# CITY OF ALBUQUERQUE

February 8, 2021

RE: **Lot 15 Block 9 Unit 22 SAD 228**  
**3300 Calle Facio NW**  
**Volcano Cliffs Subdivision**  
**Grading and Drainage Plan**  
**Engineers Stamp Date 1/28/2021 (H12D003C)**

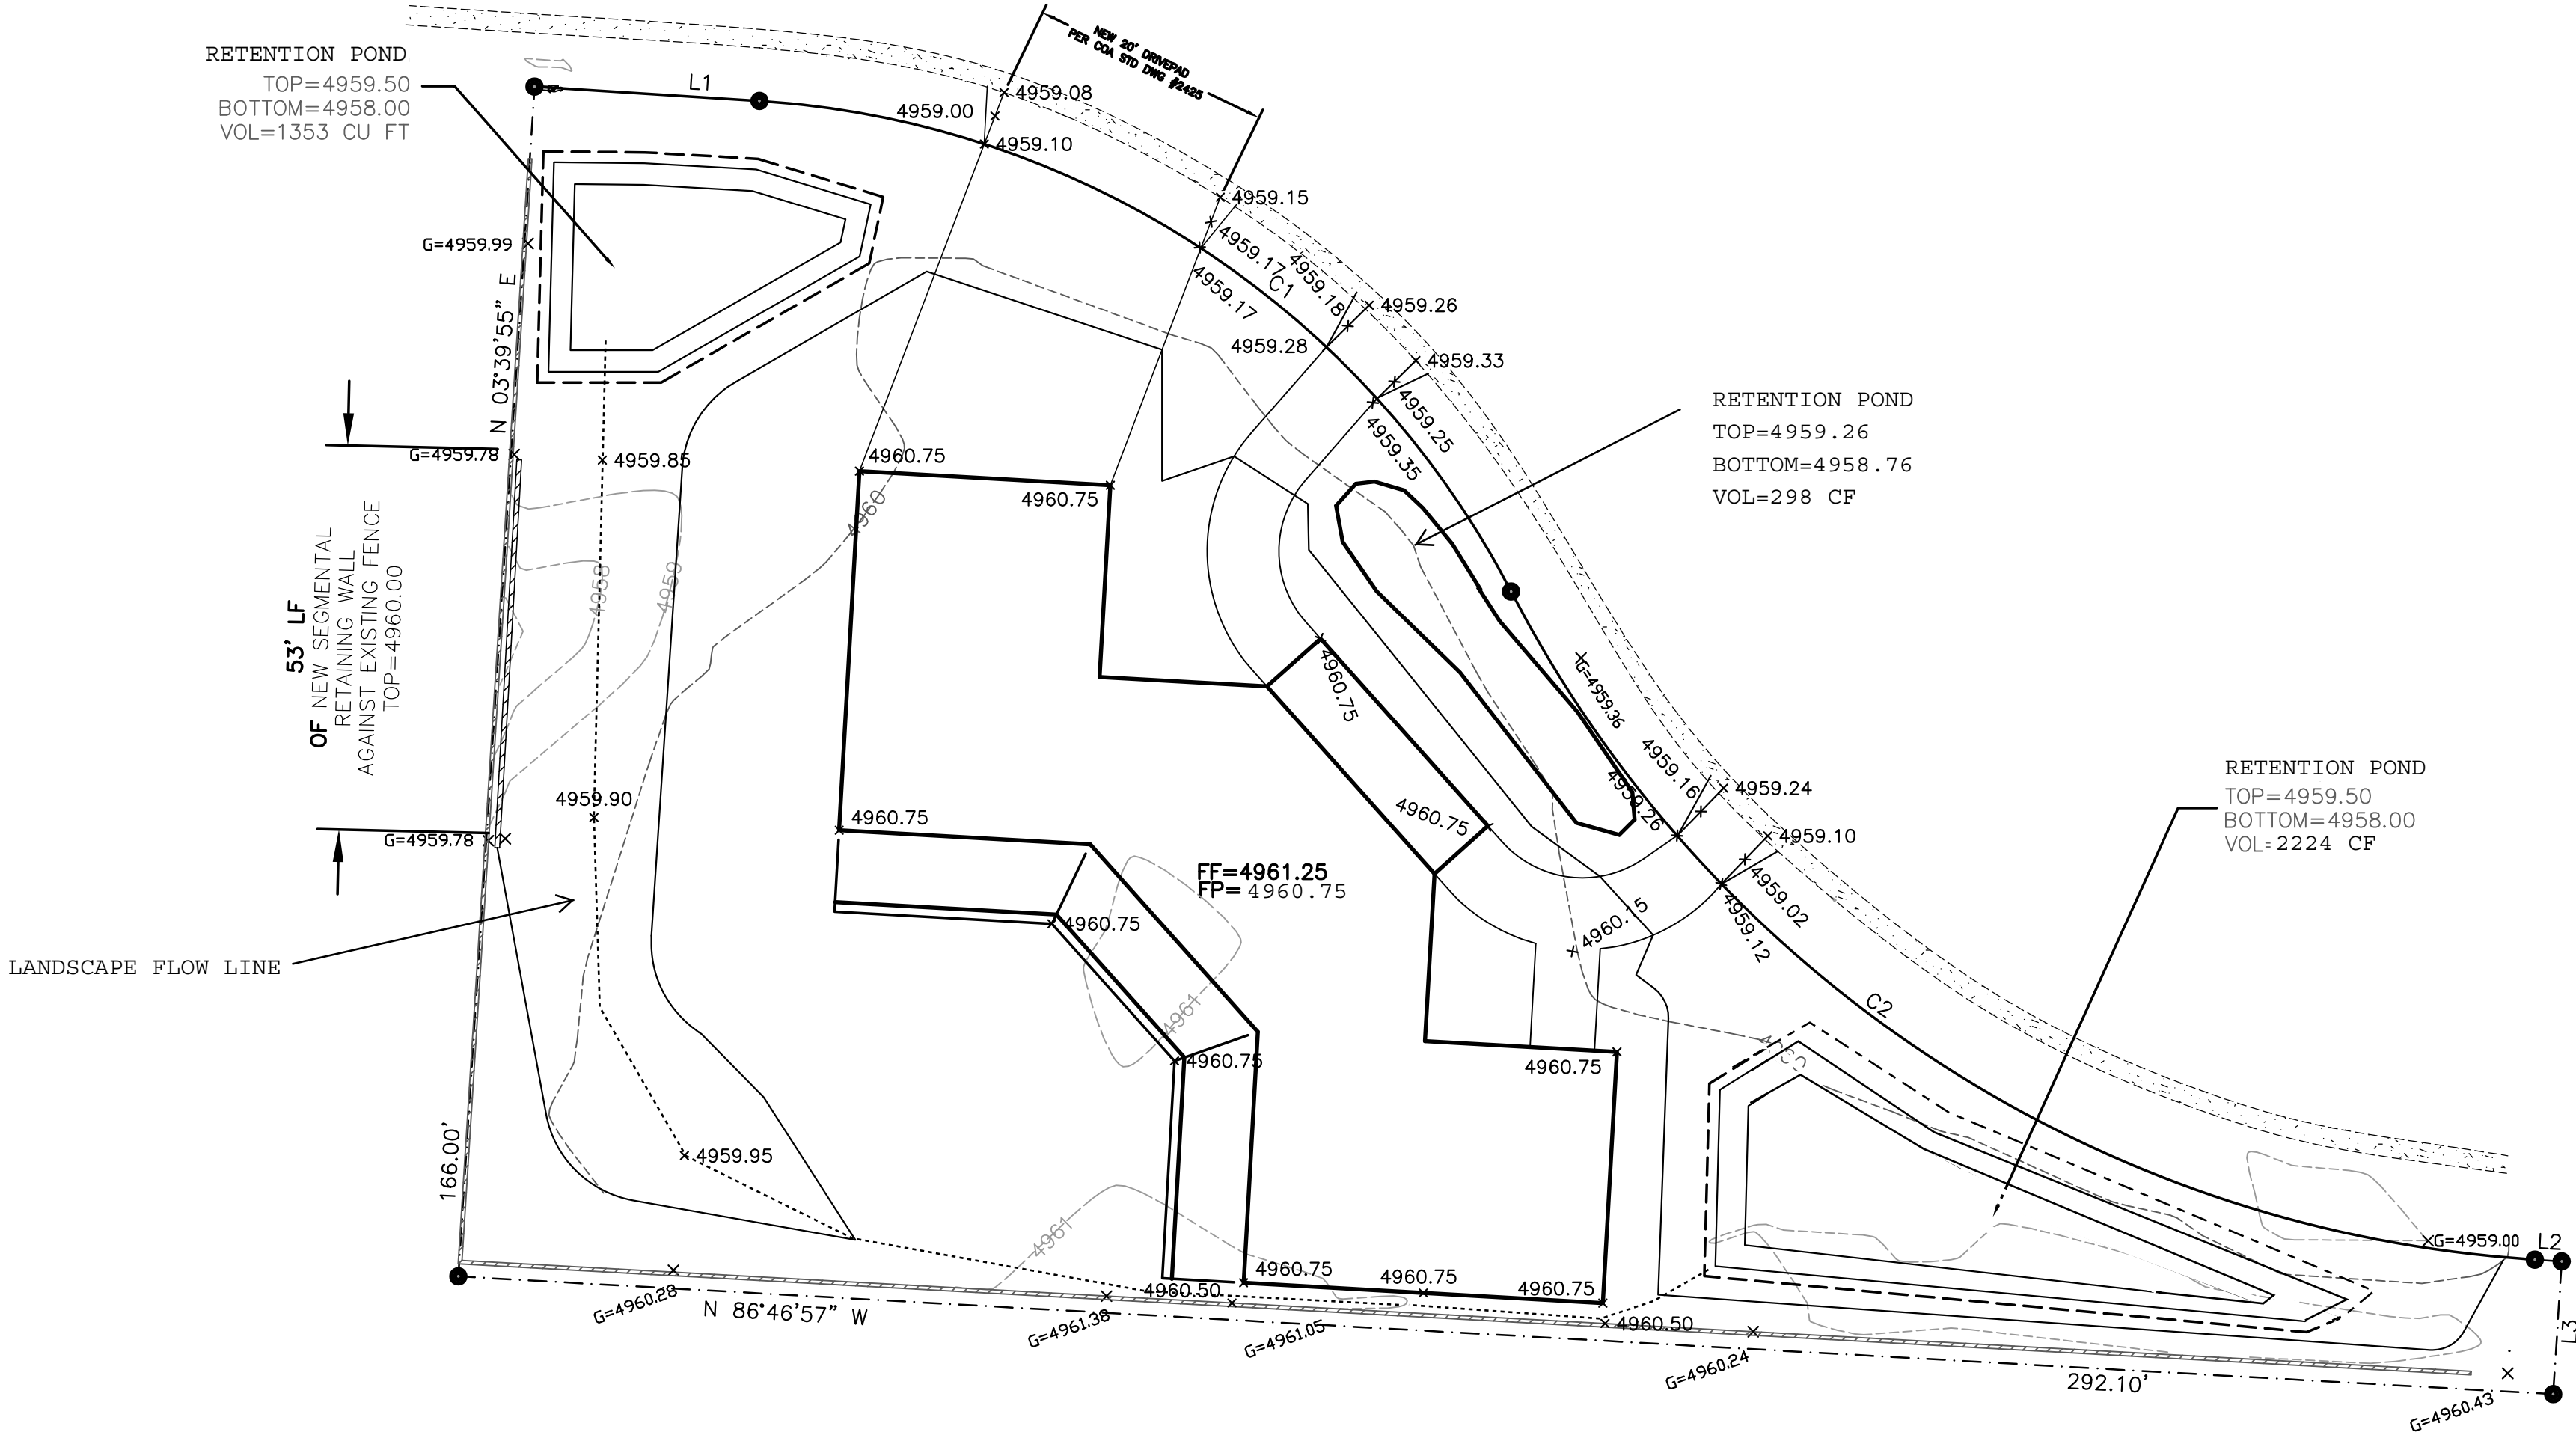
**Prior to Building permit approval a Pad Certification will be required, provided by the Engineer or a registered Land Surveyor.**

**Advise the owner contractor not to use dirt as a ramp to climb the curb, use lumber or crusher fines for this purpose.**

Reiterate to the Owner/Contractor that a separate permit for a garden/retaining wall must be obtained with the approved G&D plan and Pad Certification. Also, if a swimming pool is to be placed the grading and drainage plan will change and will need to be resubmitted.

**Prior to Certificate of Occupancy release, Engineer Certification per the DPM checklist is required.**

Based upon the information provided in your submittal received 1/29/2020, this plan is approved for Grading Permit.
